STAFF REPORT 11-12-2020 MEETING

APPLICATION NUMBER: 20-6938

ADDRESS: 2221 WABASH

SCOPE: REVISION OF PREVIOUSLY-APPROVED APPLICATION, DEMOLISH AND REBUILD HOUSE, REPRODUCING HISTORIC FRONT FAÇADE

3 NORTH ELEVATION
A1.1 SCALE: 1/4" = 1'-0"

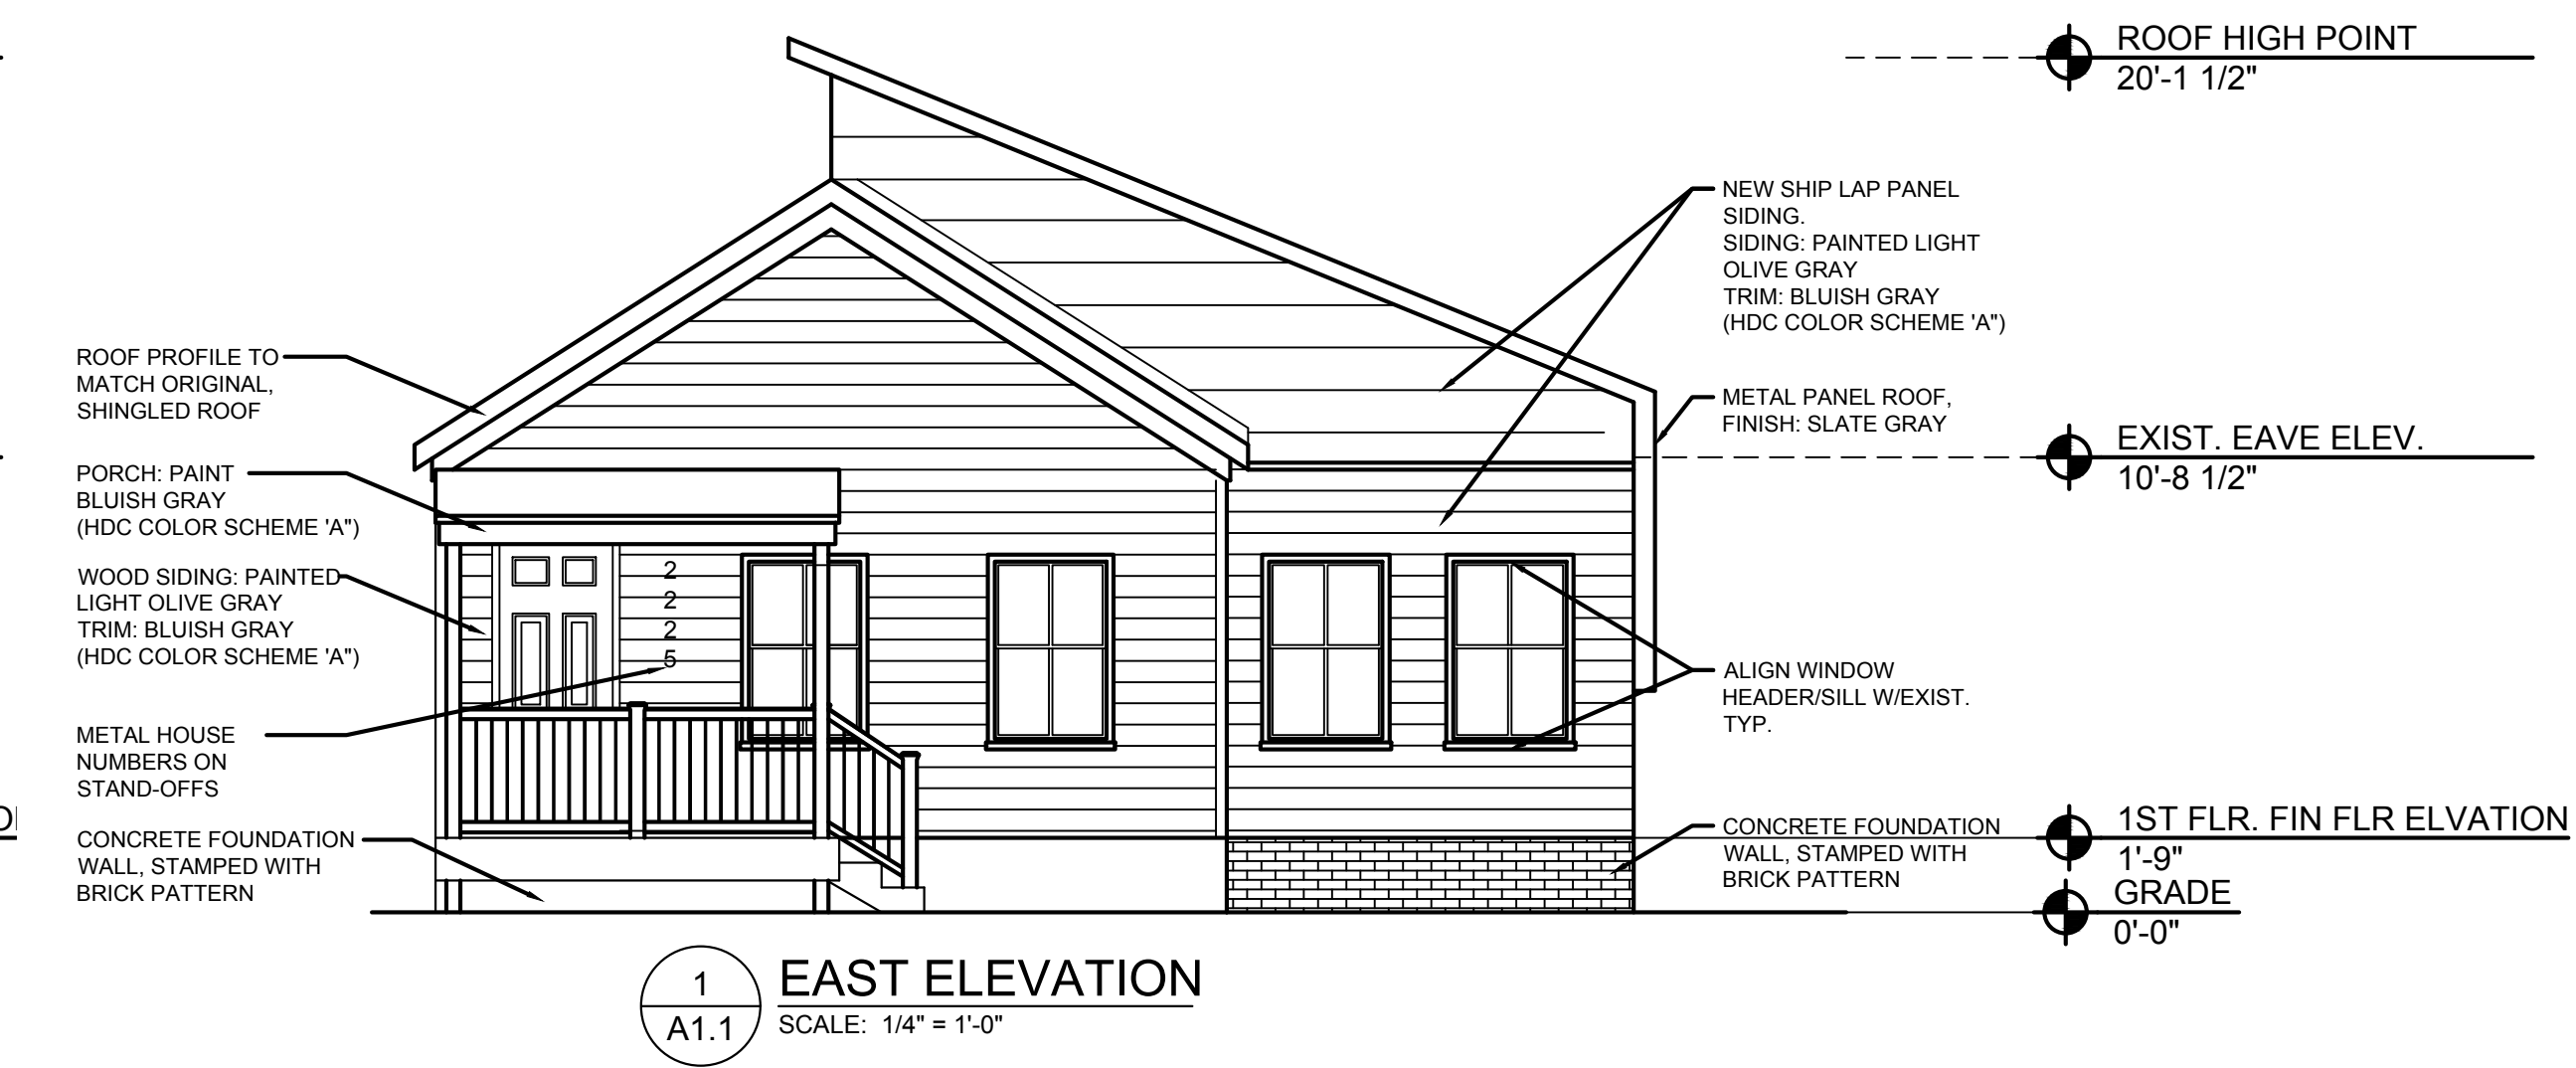
- The entire front façade/porch, including wall framing, finishes and trim, preserved and rehabilitated in place per the original drawings; and remains in situ and erect throughout construction (drawings should clearly show how this is accomplished)

- Concerning the structural engineer’s revised September 2020 report: while staff concedes that the reported issues weigh heavily against the technical and feasible retention of the front of the house *as part of this design solution*, if weighed against the *current* existing condition of the house there is no necessary reason to pursue such an aggressive alteration which “forces” the demolition question. Rephrased, if the house continues to exist in its current modest form without any major alteration proposed, it is doubtful that a total or partial demolition would be necessary or warranted, and the historic front elevation would thus be preserved, meeting the Standards. The Commission is not compelled to find a house should be demolished if it is the approach of a particular design proposal that makes the demolition necessary rather than any intrinsic and intractable problems with the structure in its current state (the house was, after all, occupied for 120 years without incident). However, this analysis must be considered in light of the Commission’s previous approval of the design.

- Staff questions whether there is an alternate design approach, completely separate from the originally approved design, that does not require aggressive alterations imperiling the front of the house and reserves expansion to the rear only.
